Inventor: Nitesh Ratnakar
Serial No.: 10/711,859
Filed: October 11, 2004
Title: Dual View Endoscope

REMARKS

ANNOTATED MARKED-UP DRAWINGS
SERIAL NO.: 11/711,859, FILED 10/11/04
INVENTOR: NITESH RATNAKAR
TITLE: DUAL VIEW ENDOSCOPE

FIG. 1

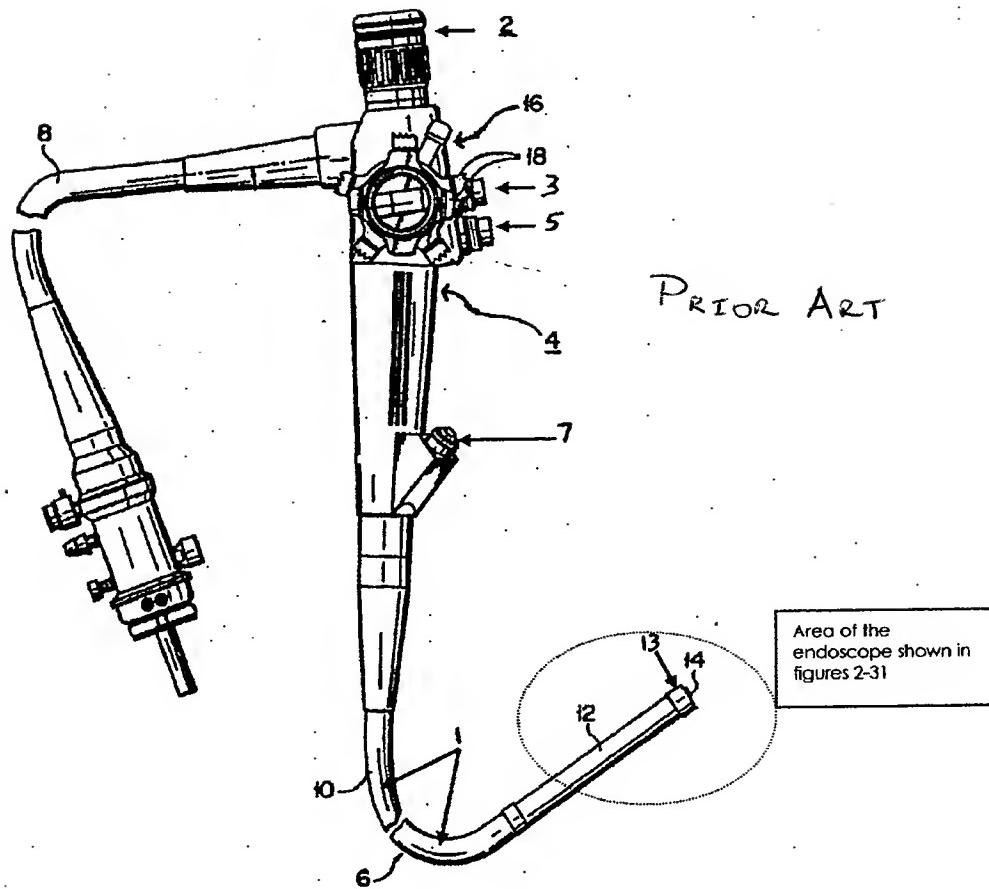
Initially, it is noted that the Examiner has requested that Figs. 1-4B be amended to add a legend identifying such figures as “Prior Art.” Applicant has amended the drawings as suggested by the Examiner and withdrawal of the Examiner’s rejection is respectfully requested. The Examiner has also requested applicant to amend the Abstract to eliminate all occurrences of the phrase “the present invention” and to reduce the length of the Abstract to a single paragraph. Further, the Examiner has requested that Applicant amend the Abstract to eliminate any reference to the purported merits or speculative applications of the invention. Per the Examiner’s request, applicant has amended the specification as suggested. As such, withdrawal of the Examiner’s objections to the Abstract is respectfully requested.
